STAFF REPORT

SUBJECT: FP-2021-0012

Quartet Southeast

Final plat consisting of 49 single-family residential buildable lots & 11 common lots on 18.95 acres of land in the R-8 zoning district.

B. Final Plat (dated: 2/2/21)

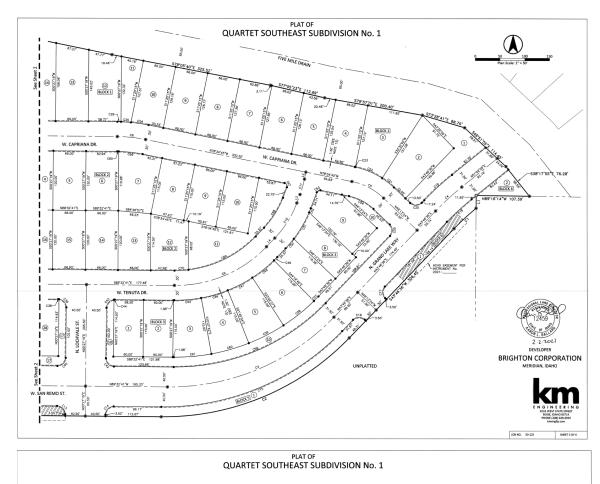
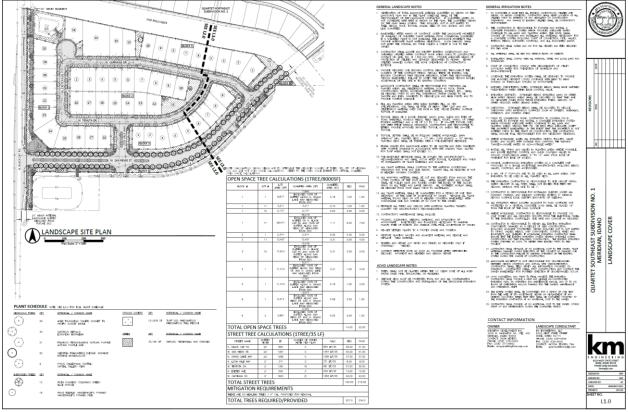
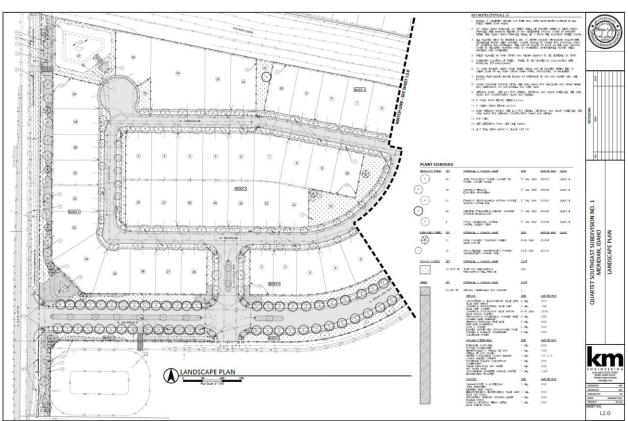
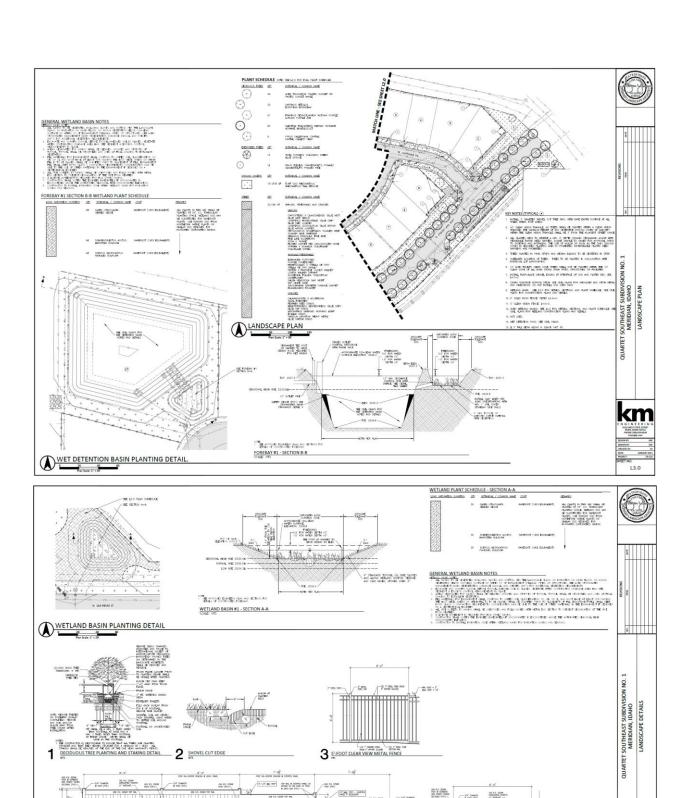
- 3. Prior to submittal for the City Engineer's signature, have the Certificate of Owners and the accompanying acknowledgement signed and notarized.
- 4. The final plat prepared by KM Engineering, stamped by Aaron Ballard, dated: 2/2/2021, included in Section V.B shall be revised as follows:

- a. Note #12: Include the recorded instrument number of the ACHD landscape license agreement.
 - b. Note #13: Include the recorded instrument number of the ACHD public right-of-way easement.

- c. Sheets 2 & 3: Include the recorded instrument number of the ACHD easement graphically depicted on the plat.
 - d. Remove the phase number from the subdivision name since the plat will be constructed in one phase.

A copy of the revised plat shall be submitted for City Engineer signature.

C. Landscape Plan (dated: 01/25/2021) & Site Amenities

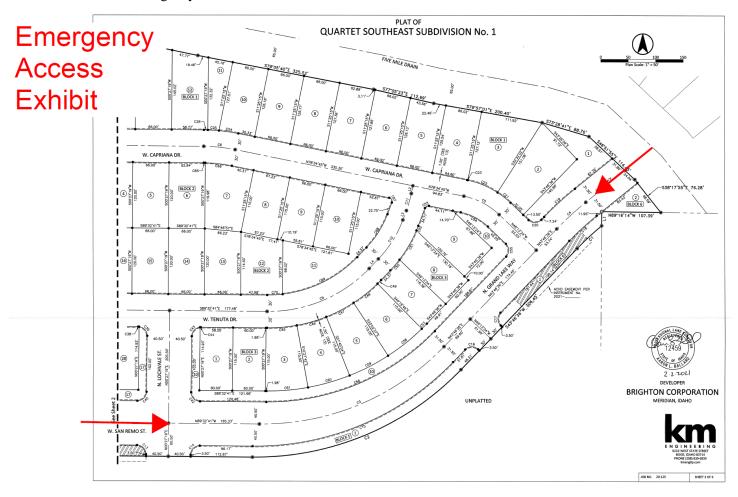
- 5. The landscape plan prepared by KM Engineering, dated 01/25/2021, included in Section V.C, shall be revised as follows:
 - a. Include shrubs along with the trees and vegetative groundcover in the street buffer along W. San Remo St./N. Grand Lake Way as set forth in UDC 11-3B-7C.3a.

- b. Remove the phase number from the subdivision name since the plat will be constructed in one phase.
- 6. The existing home to be retained on Lot 14, Block 1 is required to disconnect from private systems and hook up to City water and sewer service within 60 days of such services becoming available as set forth in MCC 9-1-4 and 9-4-8 respectively. Existing wells may be used for irrigation purposes only.
